Comments on Energy Star Lamps Product Specification Framework Comments

Comparing Nadir Zone Illumination Required Per Original and Final Energy Star Omnidirectional Pattern Specifications

FIG. 1

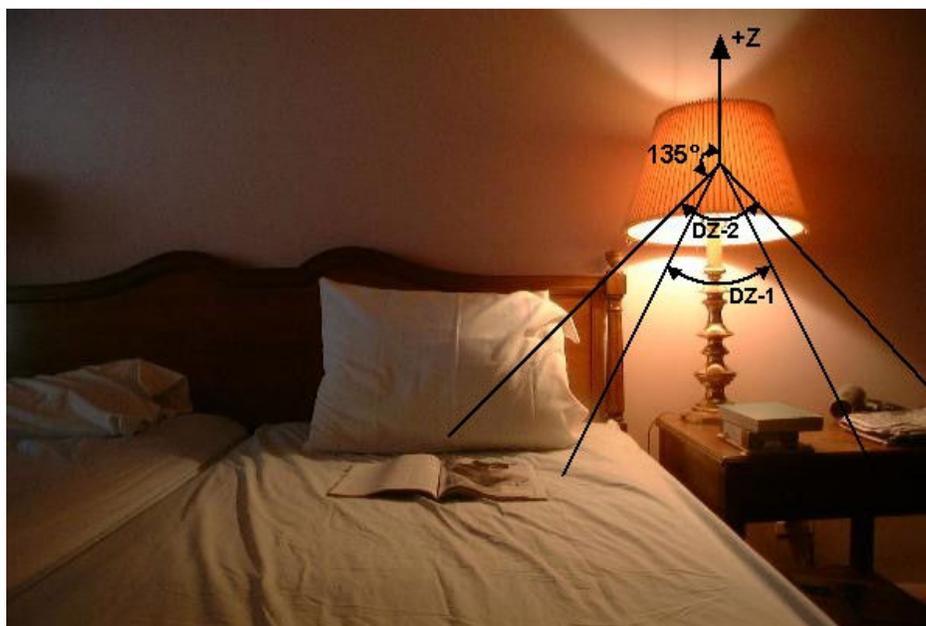
The photo in FIG. 1 below shows a table lamp in typical use on a nightstand. The original Energy Star uniformity standard for omnidirectional LED lamps specified uniformity of within +/- 10% from average in the polar angle range from 0° to 150°¹. Ultimately, in Version 1.0² and subsequent versions of the standard, the uniformity requirement was relaxed so that light intensity in the polar range from 135° to 180° only needed to be 30% of the intensity in the polar angle range in the polar angle range 0° to 135°. The polar angle range 135° to 180°, labeled DZ-2 in FIG. 1 (with the aid of some light scattered by the lamp shade) provides the light for reading and other tasks for the light from table lamps are used, so it is inappropriate that this light zone be singled out and allowed have intensity that is down to 30% of the intensity in the range 0° to 135°. The Department of Energy itself conducted two studies in the late 1990's that specifically determined that it was crucial to provide high intensity in the nadir region 120° to 180°. The Energy Star standard contradicts the DoE's own research. The origins of the present standard can be traced back through the sequence of drafts. In doing so it is found that there is no rationale for contradicting the DoE's own research. The EPA should promulgate a standard that requires uniformity within +/- 10% from average in the full polar angle range from 0° to 180°, so that "omnidirectional" bulbs are actually omnidirectional with no zone arbitrarily excluded. The current standard is a step backward from the light distribution of the common household incandescent lamp. At the very least the EPA should restore the original +/- 10% within 0° to 150° standard.

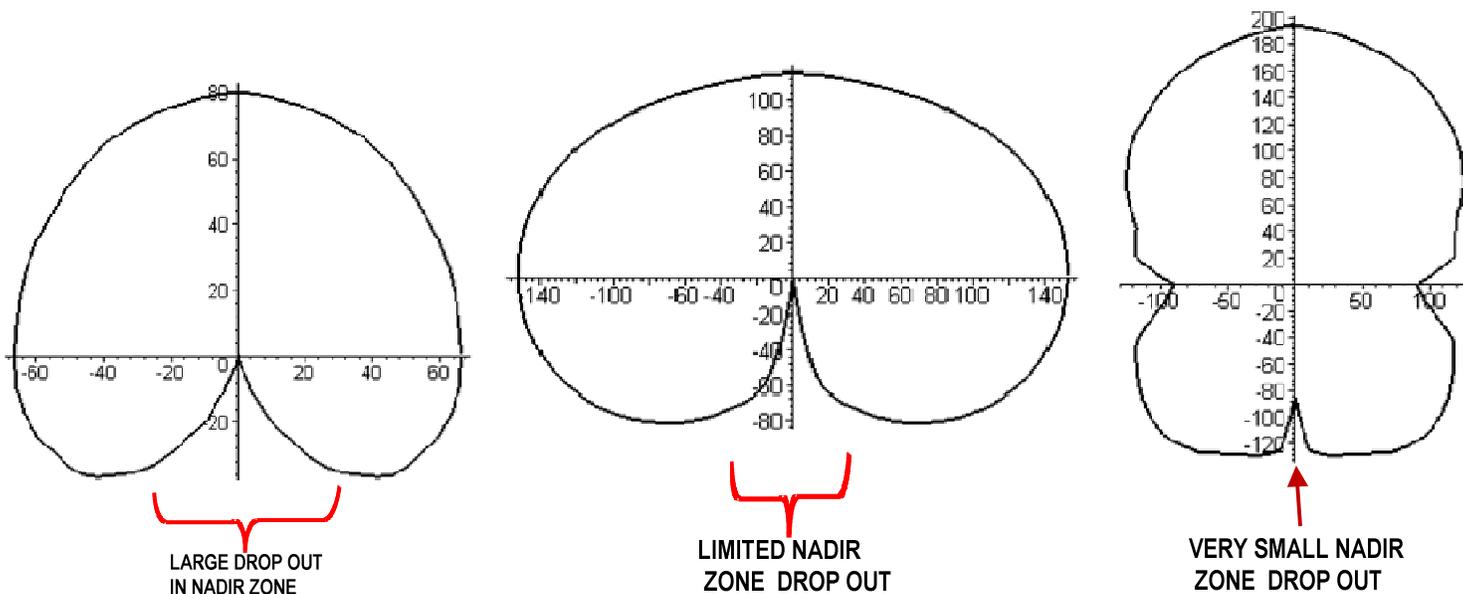
<p>Weak nadir region light intensity. Contradicts Department of Energy's Own Research Meets Energy Star but satisfies standard adapted at urging of GE lobbyists.</p>	<p>OK light Intensity in Nadir region. Standard 100 watt incandescent lamp to be phased out per 2007 EISA.</p>	<p>Stronger light intensity in nadir zone. Recommended by Department of Energy's research.</p>
--	---	---

<p>Strongly Diffused bubble remote phosphor "Snow Cone" LED replacement lamp. Weak light intensity in nadir zone which was deemed crucial by Department of Energy's own</p>	<p>100 Watt Incandescent lamp. 9.6% of light is in zone 135° to 180°. Average light intensity in 135° to 180° zone is 50% of average intensity in 0° to 135° one.</p>	<p>Circline Fluorescent. Regarded as best by Dept. of Energy's Research. LED lamps can also be made to have this very small nadir drop out zone. 15% of light is in zone 135° to 180°.</p>
---	---	--

<p>research studies. 6.5% percent of light is in zone 135° to 180°. This low amount meets the weakened Energy Star Standard. Average light intensity in 135° to 180° zone is only 25% of average intensity in 0° to 135° one.</p>		
--	--	--

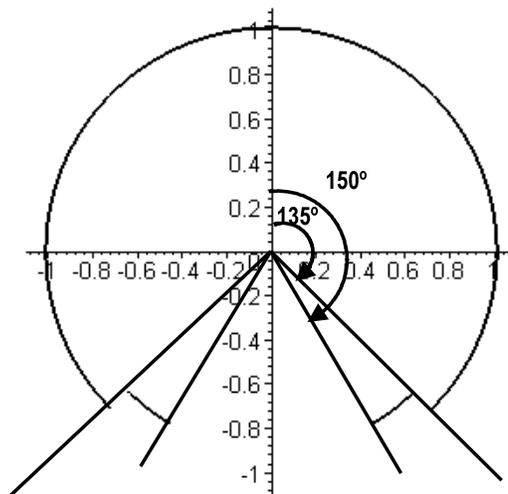
It is useful to compare the amount of light that is required to be in the nadir zone of 135° to 180° per the original (+/- 10% within 0° to 150°) draft-1 standard to what is required in the weakened (+/- 20% in 0° to 135° & 5% in 135° to 180°) current standards. The worst case scenario for the original standard as far as the nadir zone illumination would be zero normalized intensity in the range in 150° to 180°, 0.9 normalized intensity in the range 135° to 150°, and 1.0111 average mean normalized intensity in the zone in 0° to 135°. Even in this worst case scenario there would still be 1.5 times as much energy in the nadir zone compared to what is required per the weakened standard.

WORST CASE FOR NADIR ZONE UNDER ORIGINAL +/- 10% IN 0° TO 150°
INTENSITY IN 0° TO 135° IS 1.011
INTENSITY IN 135° TO 150° IS 0.9 (THE LOWER LIMIT)
INTENSITY IN 150° TO 180° IS ZERO !
PERCENT OF LIGHT FLUX IN 135° TO 180° IS 7.5% WHICH IS 1.5 TIMES
THE 5% FLUX REQUIRED BY THE WEAKENED FINAL ENERGY STAR
STANDARD

Each case: (1) consumers cherished incandescent A-lamp, (2) the Dept. of Energy's researcher's favored circline, and (3) the worst case scenario under the original, draft-1 Energy Star standard, has significantly more light flux in the crucial nadir zone than is required by the weakened current standard.

FIG. 3, CFL INTENSITY DISTRIBUTION

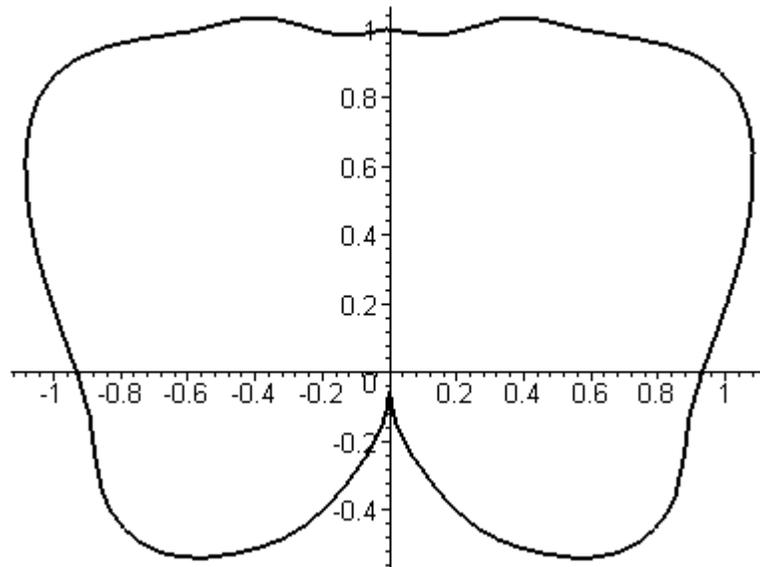
The intensity distribution of the common CFL is very weak in the nadir as shown in the polar plot below.

FIG. 5 Task Plane Illuminance (LUX) vs. radial coordinate in task plane (cm) for CFL and Incandescent lamps in lamp with lossy lamp shade

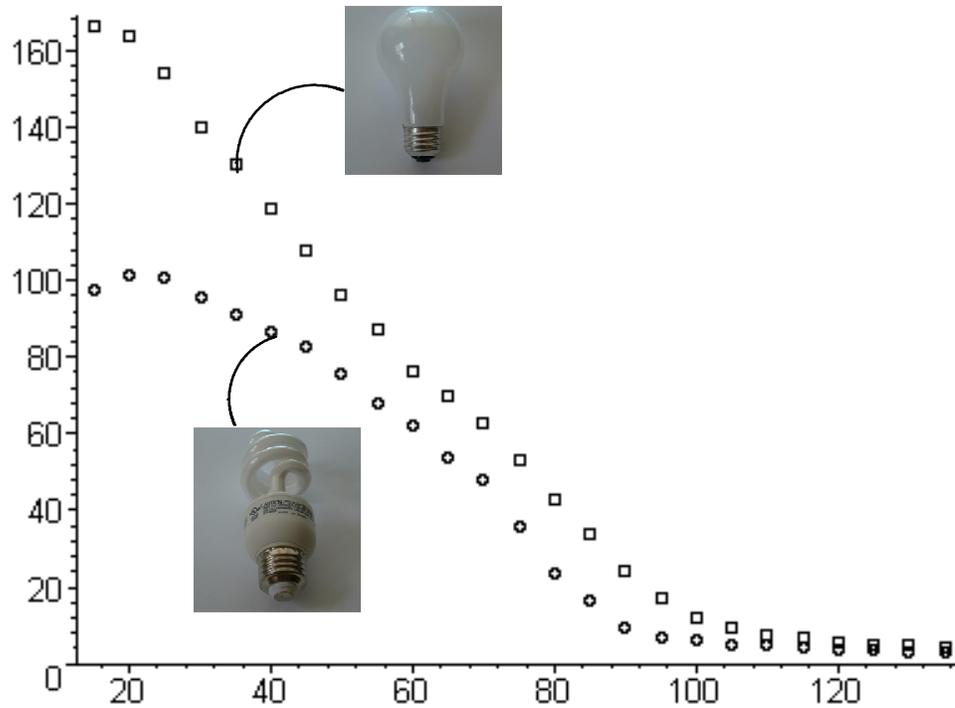
FIG. 5 shows the plotted illuminances of the common CFL and traditional incandescent lamp when used in a table lamp with a somewhat absorbing (lossy) yellowed old lamp shade. Package information indicated that the CFL consumed 13 watts and produced 825 lumens, and that the incandescent consumed 60 watts and produced 840 lumens (2% more).

As shown in FIG. 5 the CFL produced substantially less task illuminance despite the fact that it produced about the same total lumens. The ratio of the illuminances is shown in FIG. 6. It varies between 1.2x and 2.5x. Note that the large peak in the ratio is located at a distance where a person in the vicinity of the lamp is likely to be situated, for example a person seated in an easy chair next to a table lamp on which the lamp is located.

FIG. 7 Task Plane Illuminance (LUX) vs. radial coordinate in task plane (cm) for CFL and Incandescent lamps in lamp with reflective lamp shade.

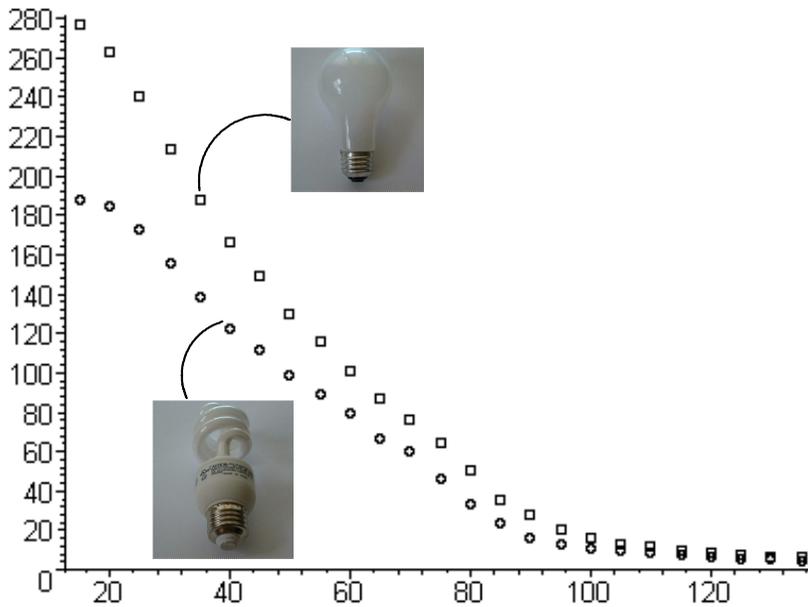
FIGs. 7 and 8 show the task plane illuminances and their ratio when using a lamp shade with a highly reflective white liner.

Also, in the case of a lamp shade with a highly reflective white liner, the common incandescent lamp produced significantly greater (1.25x to 1.75x) task plane illuminance compared to the CFL even though both light bulbs produced nearly the same total lumens.
